THIRD PARTY PLANNING OBJECTION IN RESPECT OF SOUTH DUBLIN COUNTY COUNCIL PLANNING APPLICATION, REG. REF. SD21A/0139, WHICH PROPOSES DEVELOPMENT COMPRISING OF: THE DEMOLITION OF THREE EXISTING APARTMENT UNITS (C. 239SQ.M) AND BIN STORE (C.18SQ.M) AND THE CONSTRUCTION OF A RESIDENTIAL DEVELOPMENT ARRANGED IN TWO BUILDING BLOCKS (BLOCK A & BLOCK B) RANGING FROM 3 TO 6 STOREYS IN HEIGHT OVER BASEMENT LEVEL (C. 3,728SQ.M, INCLUDING BASEMENT). BLOCK A COMPRISES 11 RESIDENTIAL APARTMENTS (C. 1256SQ.M) IN A 5 TO 6 STOREY BUILDING AND INCLUDING A GROUND FLOOR LEVEL CAFE (C. 93SQ.M) AT THE BUILDINGS SOUTH EASTERN CORNER; BLOCK B COMPRISES 15 RESIDENTIAL APARTMENTS (C.1393SQ.M) IN A 3 TO 5 STOREY BUILDING; THE PROPOSED DEVELOPMENT WILL COMPRISE 26 NEW RESIDENTIAL UNITS (5 STUDIO APARTMENTS, 6 1-BEDROOM APARTMENTS, 7 2-BEDROOM APARTMENTS & 8 3-BEDROOM APARTMENTS) WITH ASSOCIATED BALCONIES AND TERRACES. THE PROPOSED DEVELOPMENT WILL COMPRISE A TOTAL OF 40 APARTMENT UNITS DERIVED FROM 26 NEW APARTMENTS AND 14 EXISTING APARTMENTS; RELOCATION OF EXISTING BASEMENT ACCESS ON OLD GREENHILLS ROAD AND THE UPGRADE AND EXTENSION OF THE EXISTING BASEMENT LEVEL ; PROVISION OF INTERNAL FOOTPATHS; LANDSCAPED

FIG. 10: LIFT OVER-RUNS REFERRED TO ON THE ELEVATIONS BUT NOT ACTUALLY INCLUDED ON THE ELEVATIONS

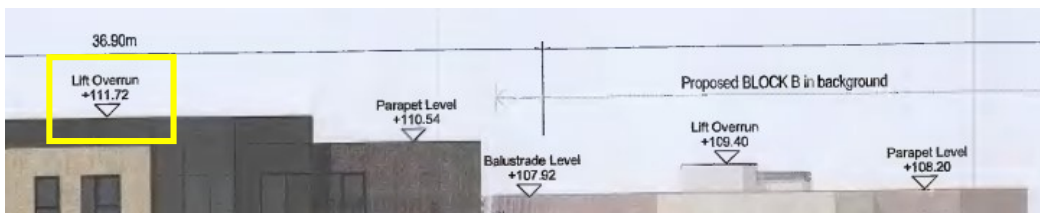
The Applicant provides for lift over-runs on the submitted elevations. These are noted with OSD levels. These levels require review as on the taller section of building the lift over-run does not appear to have been shown. +111.72 OSD is 1.18m taller than the Parapet Level of +110.54

FIG. 25: SITING & SCALE OF PROPOSED BLOCK B RELATIVE TO THE ADJOINING SINGLE STOREY DWELLING IS UNACCEPTABLE

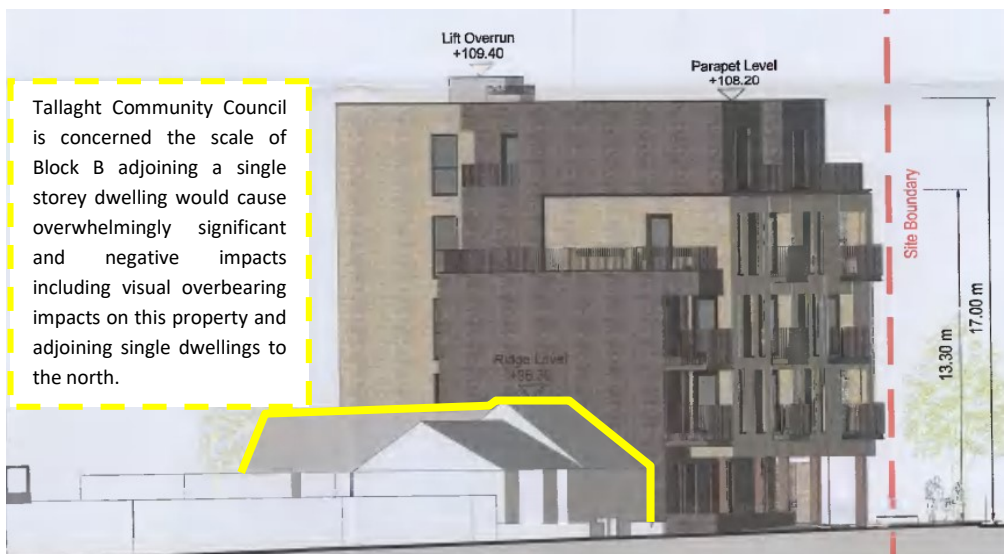
FIG. 24: THE SITING OF THE PROPOSED BLOCK B TO THE ADJOINING SINGLE STOREY DWELLING IS UNACCEPTABLE

FIG. 26: BLOCKS A & B ARE LOCATED HARD UP TO THE SHARED BOUNDARY WITH UNDEVELOPED LANDS

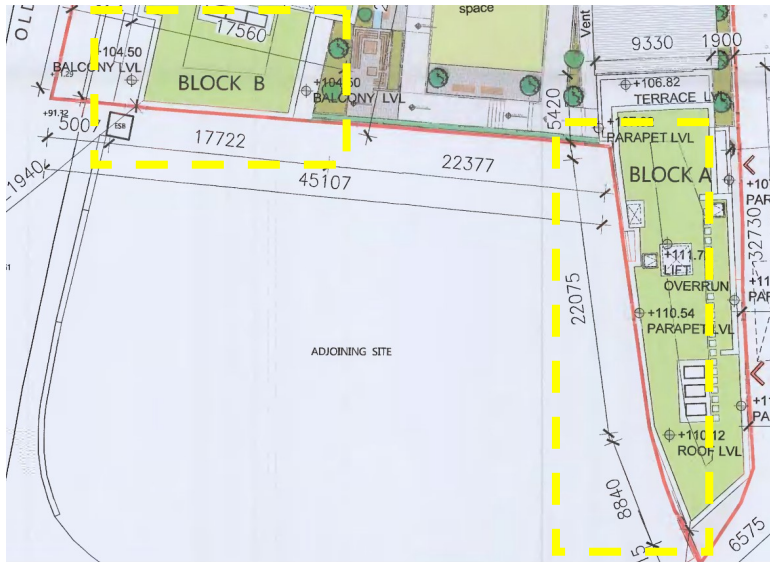
**The proposed densities and scales of Blocks A and B can only be achieved by significantly, negatively, and permanently impacting on the future residential and visual amenities of any adjoining development in the lands to the north and/or impacting on the development potential of those lands and any future scheme on these currently empty lands would likely impact on Blocks A and B. This is not acceptable.**

FIG. 28: 6 STOREY BLOCK A LOCATED HARD UP TO GREENHILLS ROAD SHARED BOUNDARY

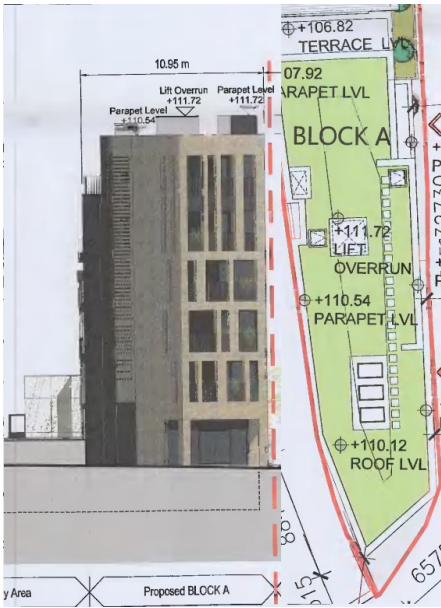
**It is one thing to have a hard edge to a streetscape, it is another to allow a new building to be visually dominant and injurious as proposed. Block A is vastly over-scaled relative to its site area and site location. It is not clear that this area of the site is developable, let alone developable as proposed.**

One of the problems with siting Block A so hard up to the eastern site boundary with the Greenhills Road is that no planting can be achieved. The Applicant Landscape Plan shows planting along the entire elevation except for in Front of Block A (see Fig. 30). This means that this section of Block A will not receive any softening of its visual impact on Greenhills Road at all by way of mitigating planting. Block A cannot reasonably be granted as proposed.

FIG. 32: COMPARISON OF EXISTING & PROPOSED SCHEMES – THE INCREASE IN SCALE IS ABRUPT & VISUALLY JARRING (1)

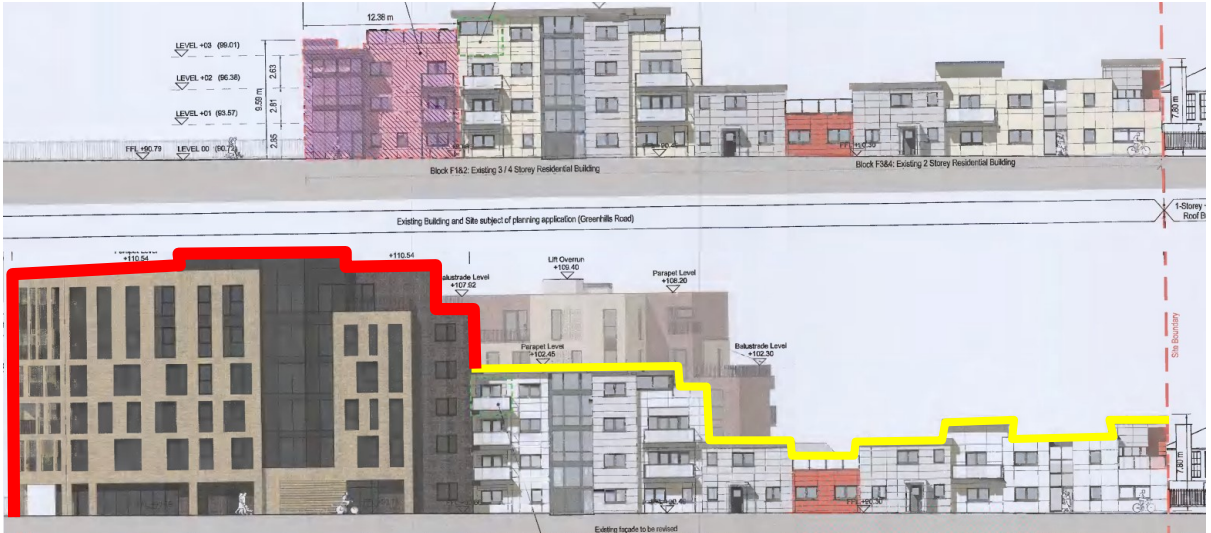
The proposed 6 storey building on Greenhills Road which would adjoin the existing 4 storey Greenhills Court scheme building would, as each of the photomontages and all the elevation and continuous elevations drawing show, be over-scaled relative to adjoining single storey properties on Old Greenhills Road and the existing 1, 2, 3 and 4 storey Greenhills Court building to which it is proposed to be attached.

FIG. 40: PROPOSED RELATIONSHIP BETWEEN BLOCK B AND NOS. 8, 9 & 10 OLD GREENHILLS ROAD

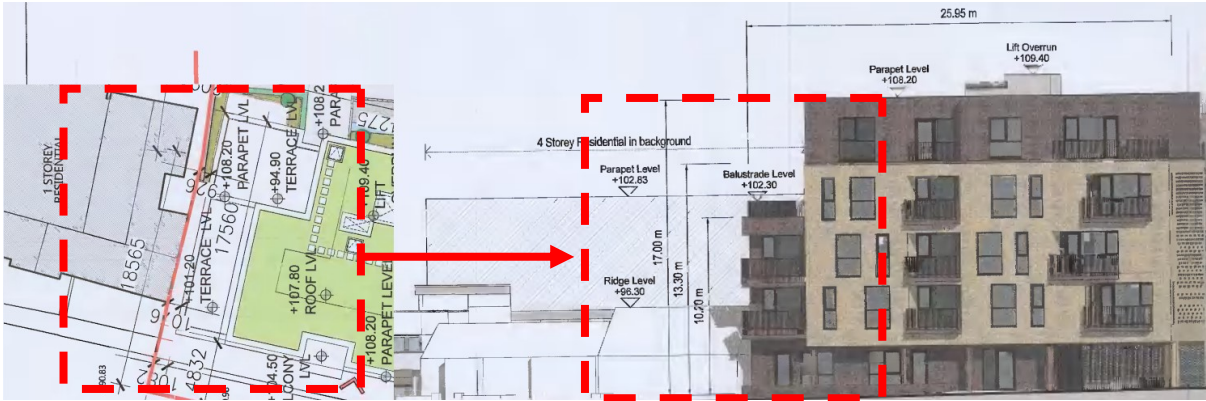
**Block B is a significantly scaled primarily 5 storey apartment block with a tiny setback to No. 8 and with only a minimal staggering of building height from 3 storeys with a terrace on top to 5 storeys. The proposed height, bulk, scale, and design of Block B adjoining No. 8 Old Greenhills Road cannot be justified by any objective view of the scheme’s context. The Applicant scheme’s many reports fail offer a credible justification for Block’s B’s proposed interface with No. 8. BPS considers that if Block B is to be permitted, then it needs to drop to 2 storeys adjoining No. 8 and then rise to 3 storeys with a significant setback. The building’s height should be limited to a maximum of 3 storeys.**

FIG. 43A: THE SITING, HEIGHT, SCALE, BULK AND DESIGN OF BLOCK B RELATIVE TO NOS. 8, 9 & 10

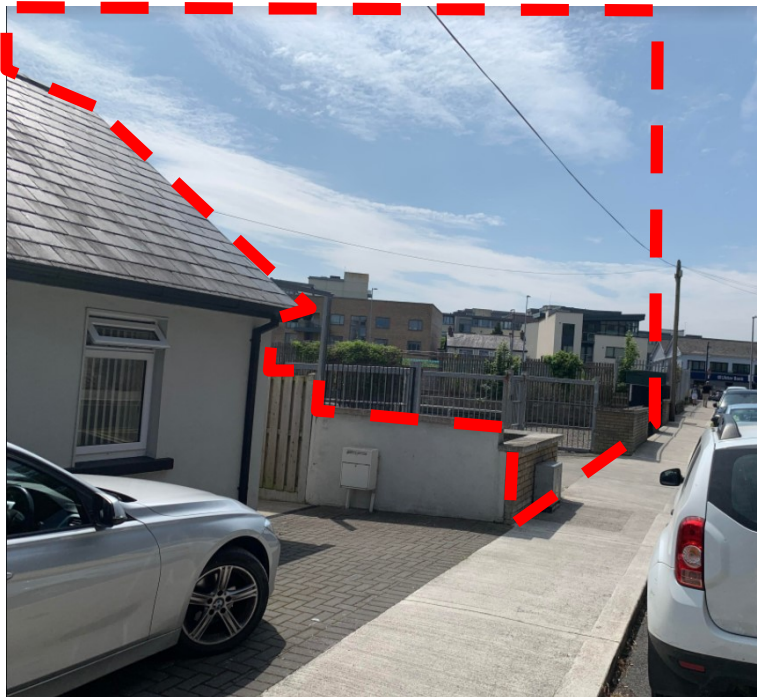
2. **The building is staggered in height from the northern boundary upwards:** The proposed stagger as Block B adjoins No. 8 begins at a height of 3 storeys with a terrace above that. This is too tall. It should start at single or at most two storeys. The 5 storey main part of the building is then far too close to No. 8 to mitigate the residential and visual impacts of Block B with respect to Nos. 8, 9 and 10 Old Greenhills Road.

FIG. 44: THE NORTH ELEVATION OF BLOCK B WHICH FACES NO. 8 & ITS FRONT AND REAR GARDENS

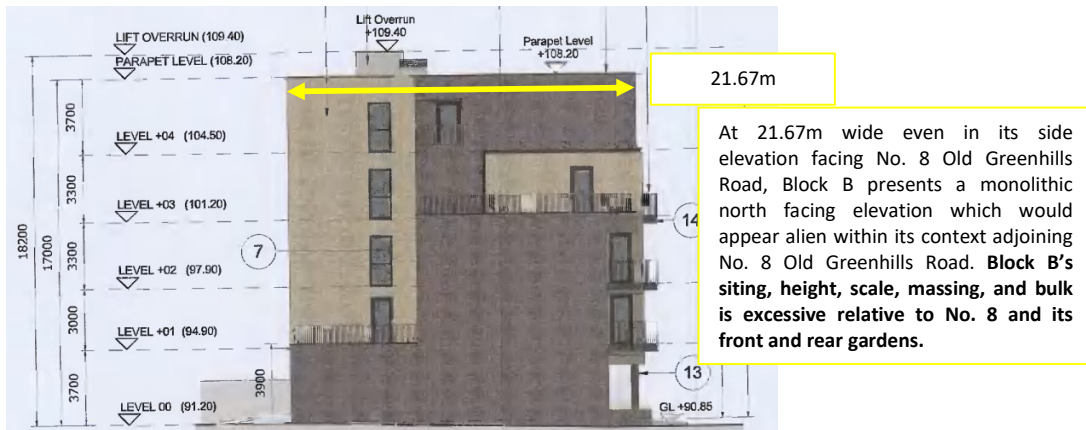
3. **A blank elevation immediately adjoins No. 8:** A 3 storey blank elevation immediately adjoining No. 8 is not attractive visually, but beyond this the north elevation of the Applicant building contains 2<sup>nd</sup> storey and 4<sup>th</sup> storey roof terraces, a 5<sup>th</sup> storey terrace, the northern sides of multiple balconies and a large number of windows that would or could enjoy views directly over Nos. 8, 9 and 10 Old Greenhills Road. This is not acceptable. The design of the north elevation does not mitigate the residential and visual impacts of Block B with respect to Nos. 8, 9 and 10 Old Greenhills Road.

FIG. 53: BLOCK B'S NORTH ELEVATION'S 2<sup>ND</sup> STOREY GLASS DOOR, TERRACE AND BALCONY (WITH VIEWS NORTH)

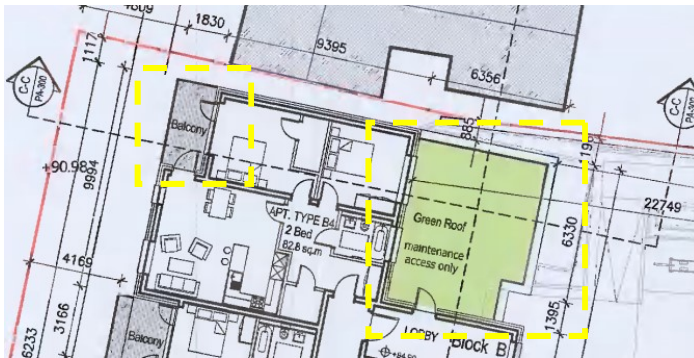
- **Overlooking impacts from the proposed second storey:** Block B's second storey – which would allow for an eye level height of 4.5m and above - contains full height glass door which faces north, a green roof with a balustrade around it which allows for access and a balcony at the north end of the west elevation with views north. Our client acknowledges that the actual second storey overlooking would be slight; however, the perception of overlooking from the large green roof and its access door creates genuine concerns. There appears to be no reason to maintain a balustrade around this area.

FIG. 54: BLOCK B'S NORTH ELEVATION'S 3<sup>RD</sup> STOREY FULL HEIGHT WINDOW AND BALCONY (WITH VIEWS NORTH)

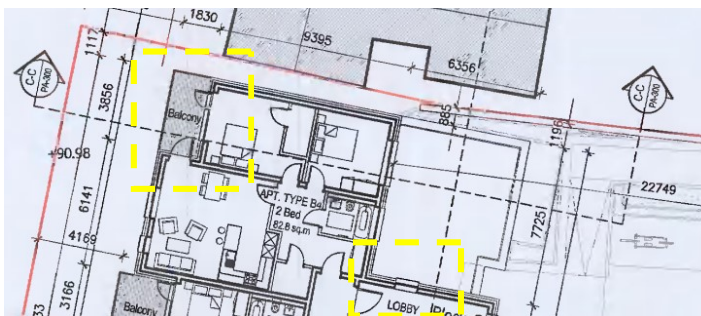
- **Overlooking impacts from the proposed third storey:** Block B's third storey – which would allow for an eye level height of 8.3m and above - contains full height glass window which faces north and serves a lobby and a balcony at the north end of the west elevation with views north. Our client acknowledges that the actual third storey overlooking would be slight; however, there is no reason why the lobby window could not be completed in obscure glass if this third storey is to be allowed to be located so close to No. 8.

FIG. 56: BLOCK B'S NORTH ELEVATION'S 5<sup>TH</sup> STOREY BALCONY & GLASS DOOR & FULL HEIGHT WINDOW

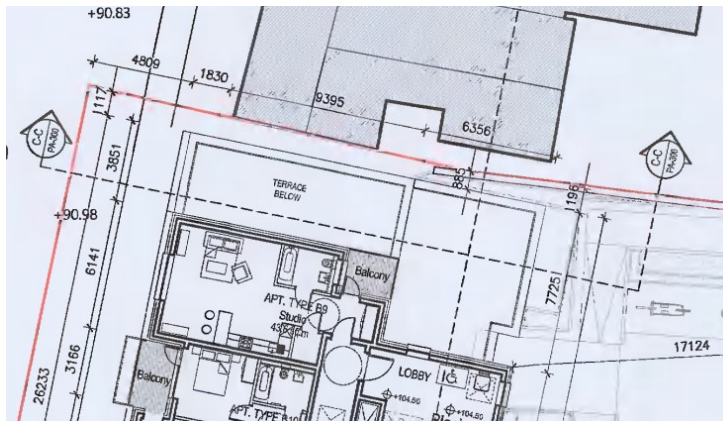
- **Overlooking impacts from the proposed fifth storey:** Block B's fifth storey – which would allow for an eye level height of approx. 14.8m - contains a large north and northeast facing balcony, served by a north facing glass door, with no restriction at all on its outward views over Nos. 8, 9 and 10 Old Greenhills Road. There is also full height glass window which faces north and serves a lobby. **BPS submits that the balcony would cause significant, negative, and permanent overlooking impacts on Nos. 8, 9 and 10 and it cannot be justified at this location.** Our client acknowledges that the actual fifth floor overlooking from the lobby window would be slight; however, there is no reason why the lobby window could not be completed in obscure glass if this fifth storey is to be allowed to be located so close to No. 8.

FIG. 57: THE EXTENT OF PROPOSED OVERSHADOWING ON 21ST MARCH AND SEPTEMBER AT 11AM

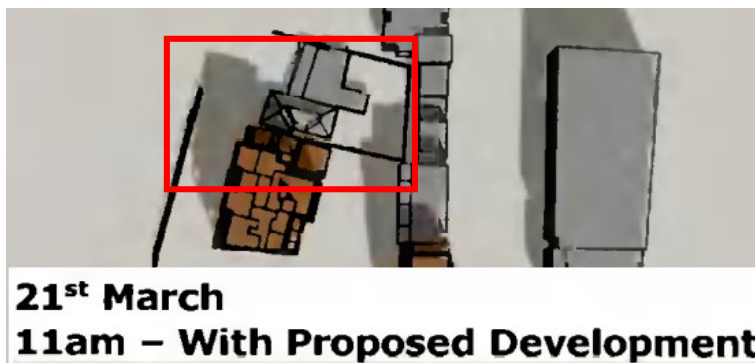
**21<sup>st</sup> March and September 11am:** Our client submits that No. 8 Old Greenhills Roads normally receives unrestricted sunlight at 11am on March and September the 21<sup>st</sup>. The Applicant scheme would cause the total overshadowing of at least half of No. 8 at this time. The website <https://www.suncalc.org/> provides that a 17m tall building will throw a shadow of 25.5m at this time. The Applicant report offers Fig. 57 as their prediction of likely overshadowing. This is far in excess of the shadow that a single or two storey dwelling would produce (which would be a shadow of approx. 10m).

FIG. 60: THE EXTENT OF PROPOSED OVERSHADOWING ON 21ST MARCH AND SEPTEMBER AT 3PM

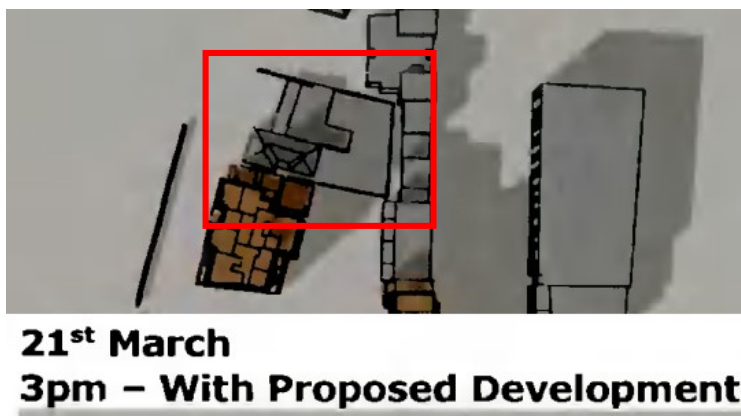
**21<sup>st</sup> March and September 3pm:** Our client submits that No. 8 Old Greenhills Roads normally receives unrestricted sunlight at 3pm on March and September the 21<sup>st</sup>. The website <https://www.suncalc.org/> provides that a 17m tall building will throw a shadow of 30m at this time. This building is directly to the south of No. 8. The Applicant report offers Fig. 60 as their prediction of likely overshadowing. **The Applicant scheme would cause the total overshadowing of No. 8 and its rear garden at this time.**

FIG. 61: THE LENGTH OF SHADOW ON 21ST MARCH AND SEPTEMBER AT 4PM

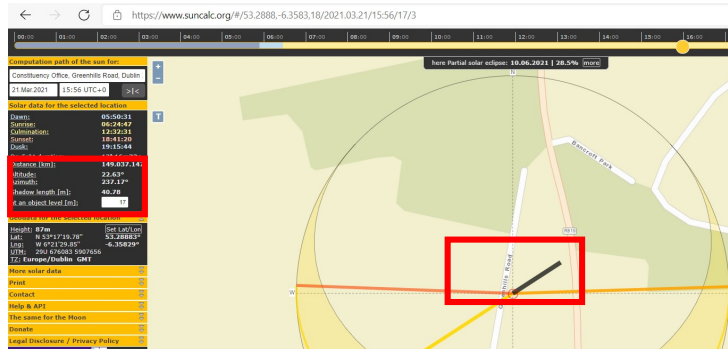
building will throw a shadow of 40m at this time. This building is directly to the south of No. 8. **The Applicant scheme would cause the total overshadowing of No. 8 and its rear garden at this time.**

FIG. 62: THE PREDICTED EXTENT OF PROPOSED OVERSHADOWING ON 21<sup>ST</sup> JUNE AT 1PM

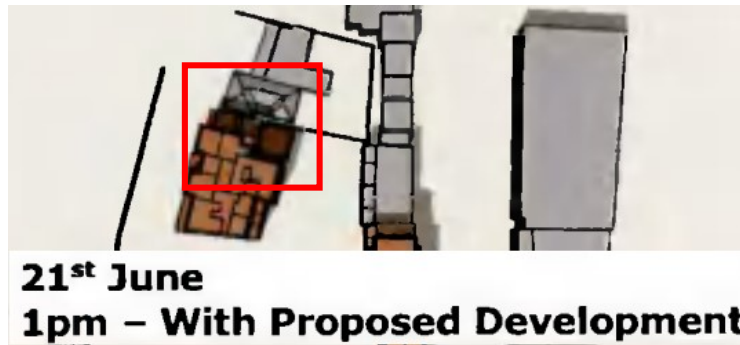
**21st June at 1pm:** Our client submits that No. 8 Old Greenhills Roads normally receives unrestricted sunlight at 1pm on June the 21st. The website <https://www.suncalc.org/> provides that a 17m tall building will throw a shadow of 10m at this time. This building is directly to the south of No. 8, and it is setback less than 10m (the closest setback is under 95cm for the 3 storey section). **The Applicant scheme would cause overshadowing of No. 8 and its rear garden at this time which appears to be under-estimated in the Applicant’s shadow diagram. The 2pm shadowing would also impact negatively on No. 8.**

FIG. 68: PROPOSED PERMANENT 25.37SQ.M BIN STORE ADJOINING THE OLD GREENHILLS ROAD

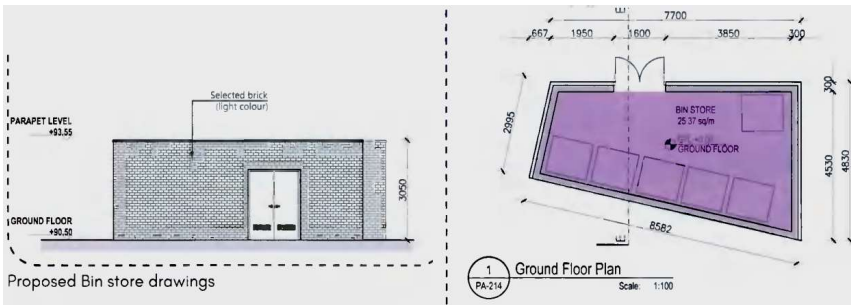
Fig. 69 below confirms that the Applicant Landscape Plan shows a hedge to screen the bin store internally but not from old Greenhills Road. The Applicant appears to care little for the quality of the public environment.

**Our client submits that the proposed location of the GoCar spaces and the bin store should be refused for the reasons set out above. There is a need to protect and to improve the streetscape at this location and to try to enhance the Old Greenhills Road within or alongside the ACA. This proposal would prevent this.**

FIG. 71A: PROPOSED BIN STORE PROPOSED TO ADJOIN NO. 10 – COURT COTTAGE – OLD GREENHILLS ROAD

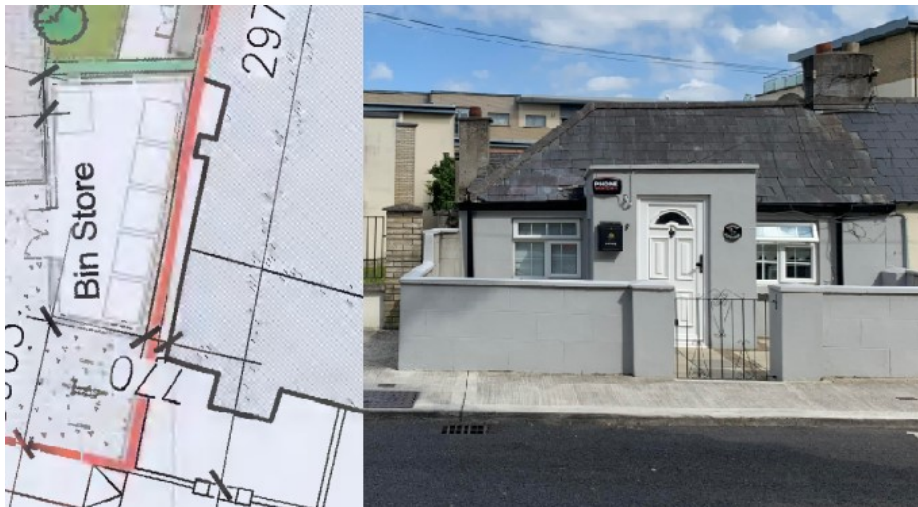
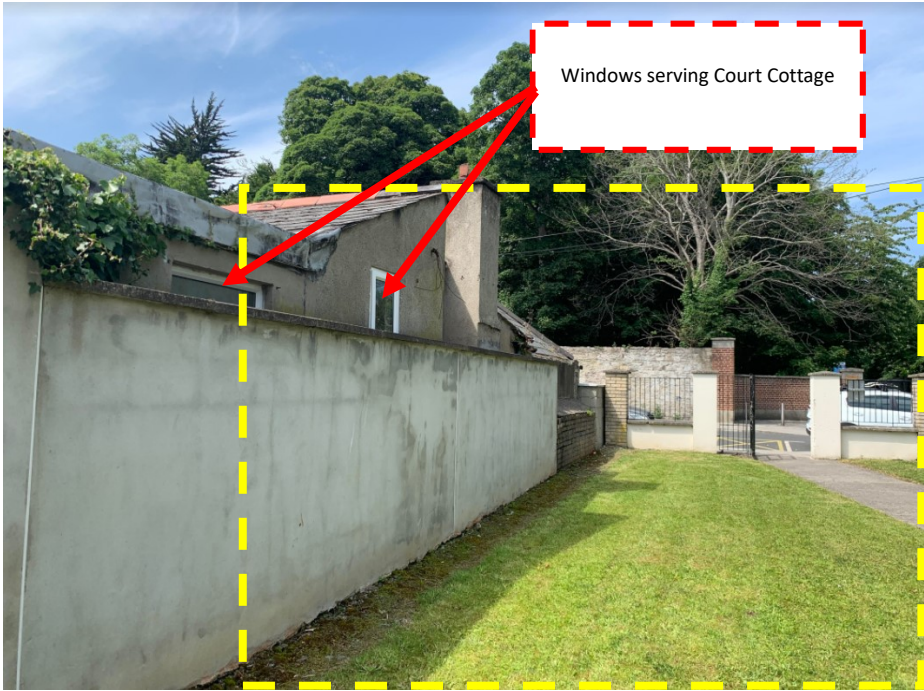
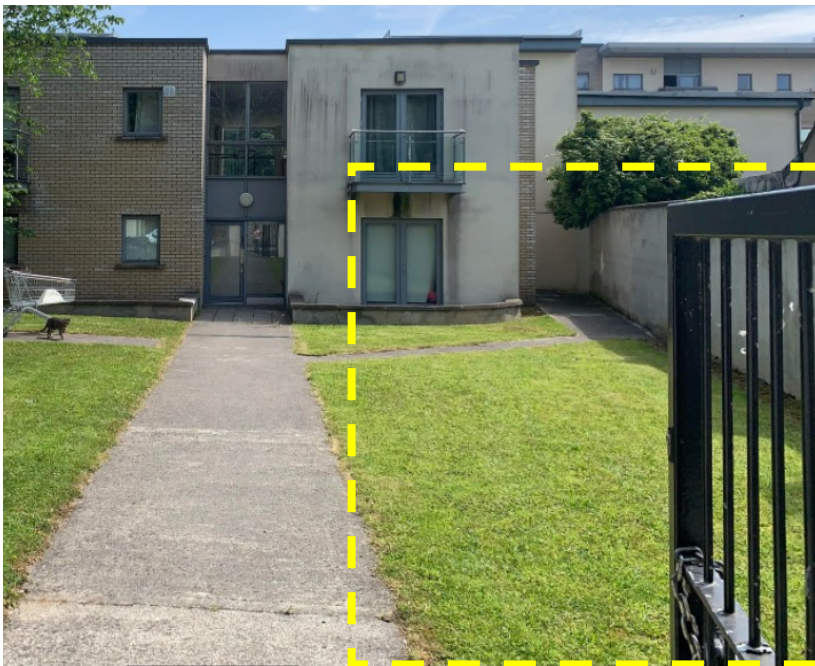
No. 10 cannot reasonably be asked to put up with the noise and smells associated with bin stores. The lids of bins bang when they are dropped, wheelie bins make noise when they are moved, the bins smell, etc. There is no reasonable basis for this bin store to be located as proposed.

FIG. 73: PROPOSED BIKE STANDS SHOULD BE RELOCATED AWAY FROM OLD GREENHILLS ROAD FOR SECURITY, ETC.

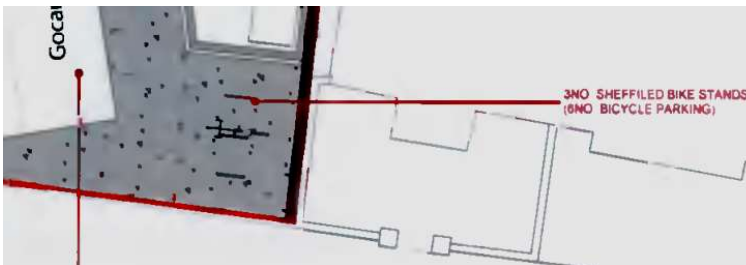
The bike stands at the location shown in Fig. 73 further congests what the Applicant appears to consider to be the service area for the scheme when this is currently an attractive pedestrian entrance to the scheme.
